22nd March 2022

Major Projects
Department of Planning, Industry and Environment
GPO Box 39
Sydney NSW 2001

**OBJECTION AND ADDITIONAL INFORMATION REQUESTS
MOSS VALE PLASTIC RECYCLING FACILITY
STATE SIGNIFICANT DEVELOPMENT
SSD-9409987**

Figure 1 Extract from WSC Section 7.11 Plan Figure 3

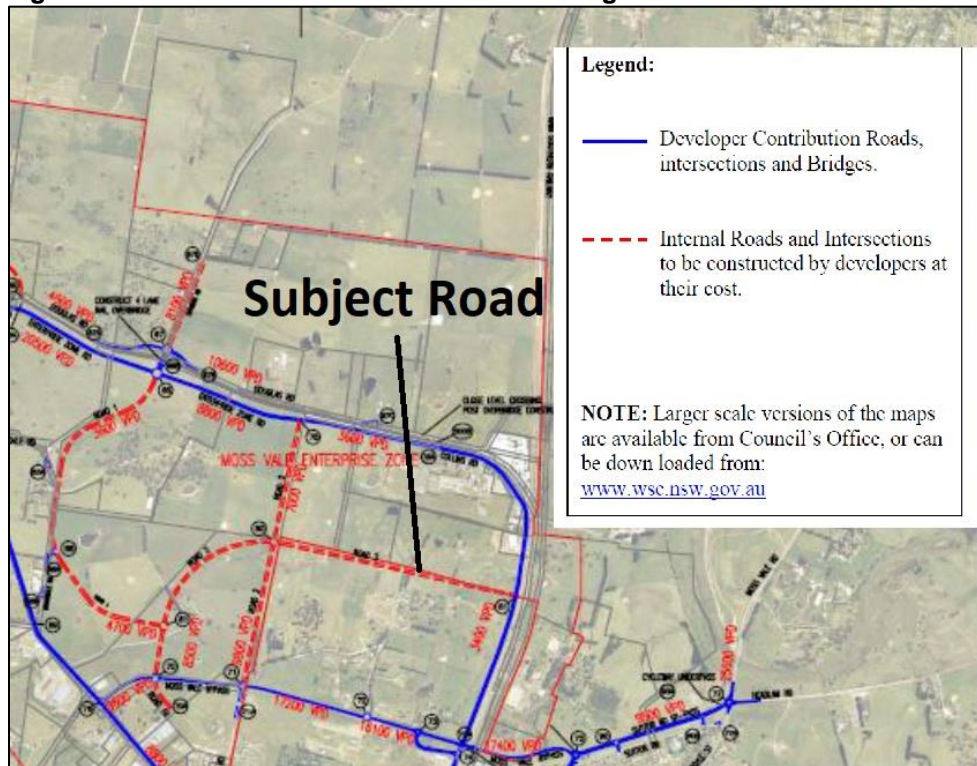
The statement of the road being shown in the Section 94 (now known as a 7.11) plan for the Moss Vale Enterprise Corridor is incorrect. The road is not identified within the contribution plan for construction from funds received from contributions, but is in fact identified as a road that is to be fully funded by the developer, see Figure 1:

Accordingly there is no mechanism available for the road to be acquired (by Council) and built in a works in kind agreement under the Section 7.11 Plan.

It is therefore fundamental to the application that consent/agreement is made with the owner's of the adjoining allotments to build the road as proposed. Evidence of this agreement is deemed to be required to allow for assessment of the application to proceed.
